Access Compliance Report Public Rights-of-Way (Pedestrian Signals)

Main Street: CERRITOS_AVE Cross Street: BROOKHURST_ST Location: SW

ADA ID: SGRK210923105424 Signal Type: One Push Button-Non APS Overall Compliance: No Severity Scores: BTN 1: 35 BTN 2: N/A No BTN: N/A

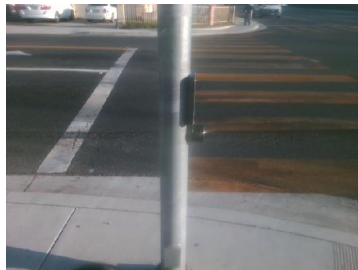
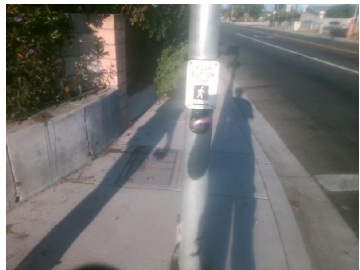
Surveyor Notes: N/A

Possible Solutions: Replace Signal Push Button With APS Button. Remove and Replace Clear Space.

OC Std/PROW: R404.2, R404.3, MUTCD 4e.08
